**Economic and Social Council**Distr.: General
9 July 2014

Economic Commission for Europe**Inland Transport Committee****Working Party on the Transport of Perishable Foodstuffs****Seventieth session**

Proposals of amendments to the ATP: pending proposals**ATP Handbook****Interpretation of external surface area measurement for panel vans****Transmitted by the United Kingdom****I. Introduction**

Figure 1

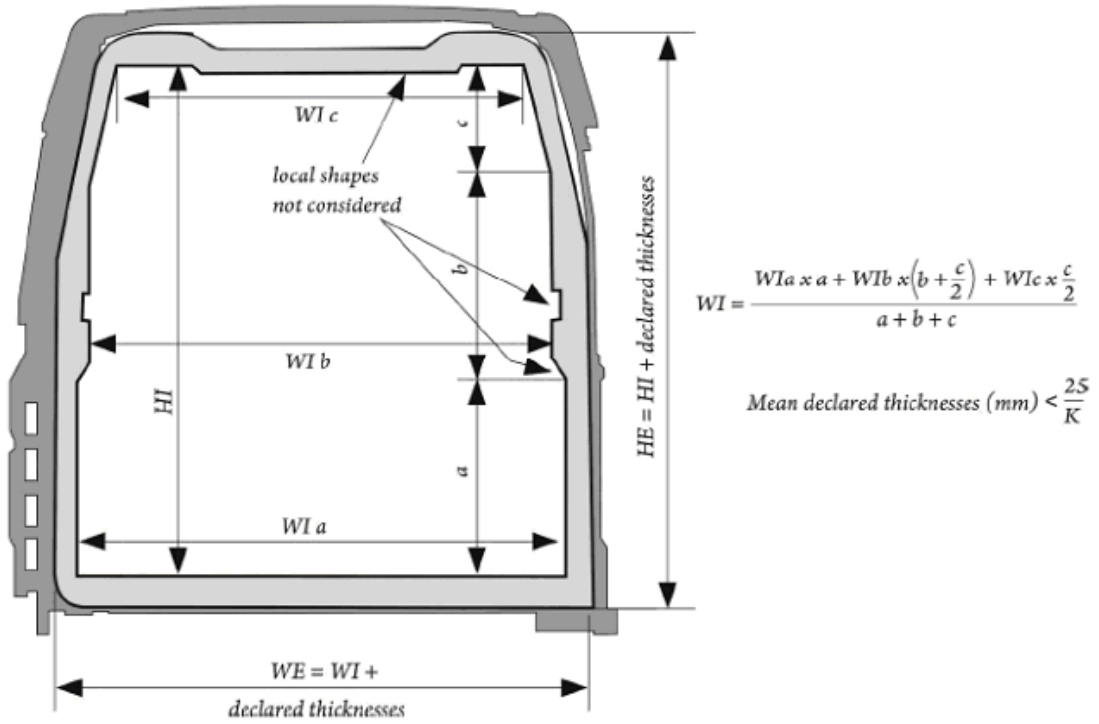
Method B. The manufacturer shall provide drawings and the competent authority shall use the calculations according to the schemes and formulae in the ATP Handbook (using either figures 1, 2 or 3 along with figures 4 and 5).

VI. Using figures 1, 4 and 5

Method A (manufacturer's drawings - excluding wheel arches)						
Si	Se	S	W	Delta T	k	
29.27	35.11	32.05	300	25	0.374	
Method B (using described diagrams - excluding wheel arches)						
Wia	1.57		Lia	4.125	Wib	1.57
Wib	1.57		Lib	4.125	Wif	1.57
Wic	1.29		Lic	4.125		
a	0.31		a	0.31		
b	0.315		b	0.315		
c	1.075		c	1.075		
WI	1.481471		LI	4.125	Wi	1.57
WE	1.701471		LE	4.328	We	1.78
Method C (using described diagrams and iteration using insulation Lambda 0.025 W/m.k)						
Wia	1.57		Lia	4.125	Wib	1.57
Wib	1.57		Lib	4.125	Wif	1.57
Wic	1.29		Lic	4.125		
a	0.31		a	0.31		
b	0.315		b	0.315		
c	1.075		c	1.075		
WI	1.481471		LI	4.125	Wi	1.57
WE	1.4815		LE	4.2474	We	1.692392
WE	1.6120		LE	4.2556	We	1.700568
WE	1.6125		LE	4.2560	We	1.70105
Results						
	Si	Se	S	W	Delta T	k
Method A	29.27	35.11	32.05	300	25.00	0.374
Method B	29.37	35.79	32.42	300	25.00	0.370
Method C	29.37	33.69	31.46	300	25.00	0.381

Figure 2

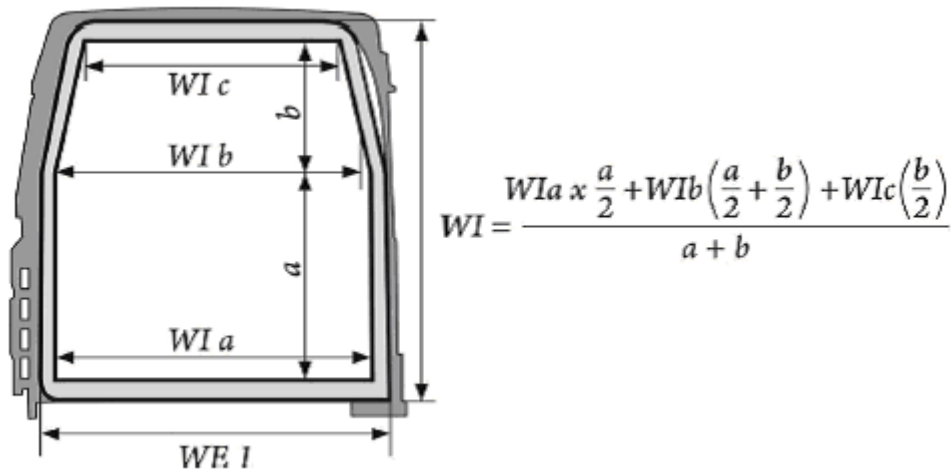
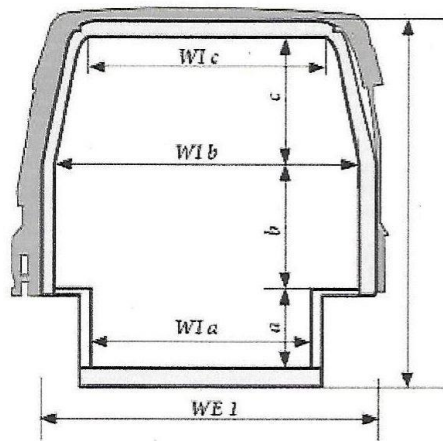
VII. Using figures 2, 4 and 5

Method A (manufacturer's drawings - excluding wheel arches)						
Si	Se	S	W	Delta T	k	
29.27	35.11	32.05	300	25	0.374	
Method B (using described diagrams -excluding wheel arches)						
Wia	1.57		Lia	4.125	Wib	1.57
Wib	1.57		Lib	4.125	Wif	1.57
Wic	1.29		Lic	4.125		
a	0.625		a	0.31		
b	1.075		b	0.315		
			c	1.075		
WI	1.481471		LI	4.125	Wi	1.57
WE	1.701471		LE	4.328	We	1.78
Method C (using described diagrams and iteration using insulation Lambda 0.025 W/m.k)						
Wia	1.57		Lia	4.125	Wib	1.57
Wib	1.57		Lib	4.125	Wif	1.57
Wic	1.29		Lic	4.125		
a	0.625		a	0.31		
b	1.075		b	0.315		
			c	1.075		
WI	1.481471		LI	4.125	Wi	1.57
WE	1.6039		LE	4.2474	We	1.692392
WE	1.6120		LE	4.2556	We	1.700568
WE	1.6125		LE	4.2560	We	1.70105
Results						
	Si	Se	S	W	Delta T	k
Method A	29.27	35.11	32.05	300	25.00	0.374
Method B	29.37	35.79	32.42	300	25.00	0.370
Method C	29.37	33.69	31.46	300	25.00	0.381

Figure 3

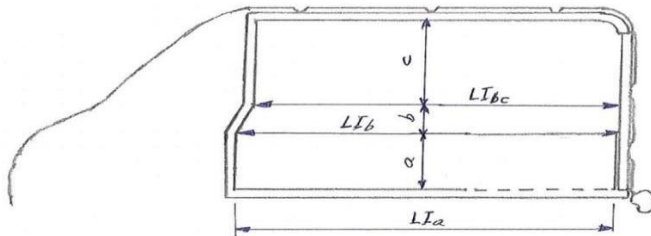
$WE = WI + \text{mean declared thicknesses}$

$$WI = \frac{((W1b \times b) + (W1b \times c) - ((W1b - W1c) \times c) + (W1b \times a) + (2 \times ((W1b - W1a) \times a)))}{(a + b + c)}$$

- $W1a$ internal width between the wheel arches
- $W1b$ internal width above the wheel arches
- $W1c$ internal width of the roof
- a internal height of the wheel arches
- b internal height above the wheel arches
- c internal height above the wheel arches where the side wall width ends

Figure 4

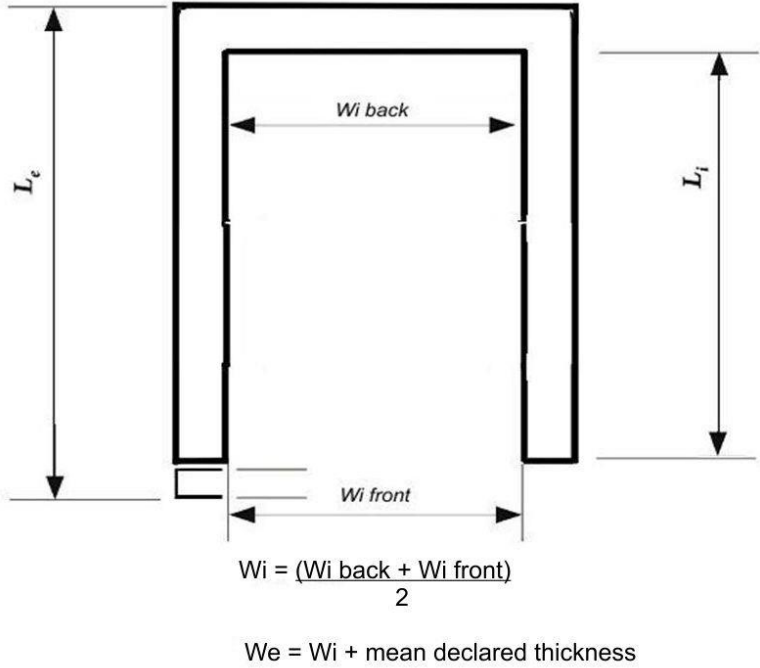
$$LI = \frac{((LIa \times a) + (LIb + LIc) / 2 \times b + (LIc \times c))}{(a + b + c)}$$

Figure 5

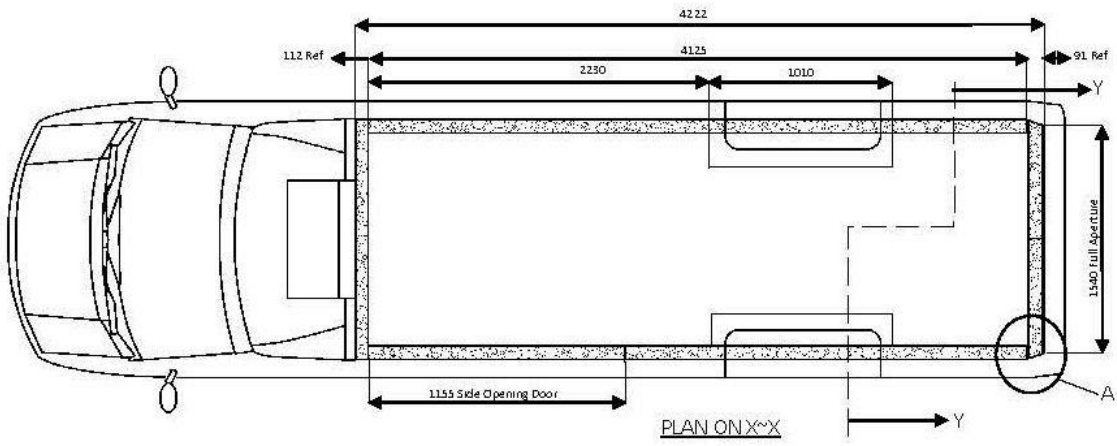
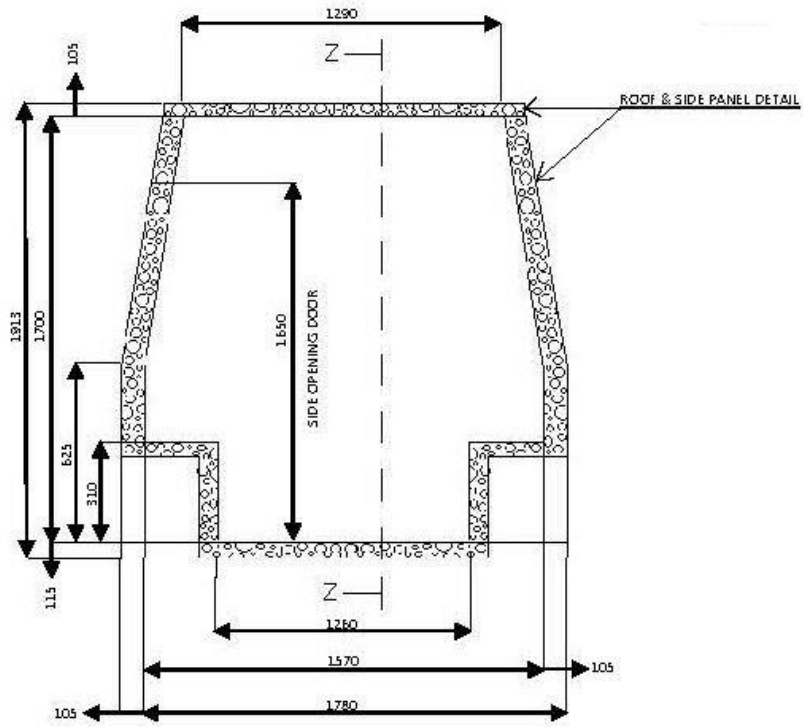
$LE = LI + \text{mean declared thickness}$
